# UNITED STATES PATENT AND TRADEMARK OFFICE

APPLICATION NO.	FILING DATE	FIRST NAMED INVENTOR	ATTORNEY DOCKET NO.	CONFIRMATION NO.
10/077,665	02/14/2002	Garrett Andrew Smith		2982

## Office Action Summary

### **DETAILED ACTION**

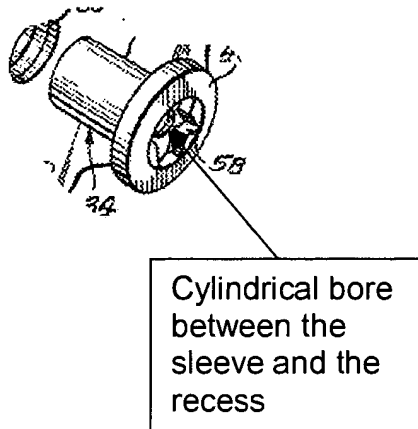
6. Applicant's arguments filed 12-24-2004 have been fully considered but they are not persuasive. Applicant contended that the bolt of Kirrish has a head with a tool interface means and the tool interface does not form part of the cylinder of the bolt. In response, in figure 1, it can be seen that the nut (34) has a cylindrical hole passing through the sleeve (50) and the head (48). The cylindrical hole has three sections; one section is in the sleeve, another is in the tool recess (58) of the head and a smaller section joining the hole in the sleeve and the tool recess. In addition, Kirrish clearly discloses that the nut comprise a head portion and a sleeve portion and a bore 52

extends through the sleeve, which means that the hole extends beyond the sleeve. See attached drawing section below.
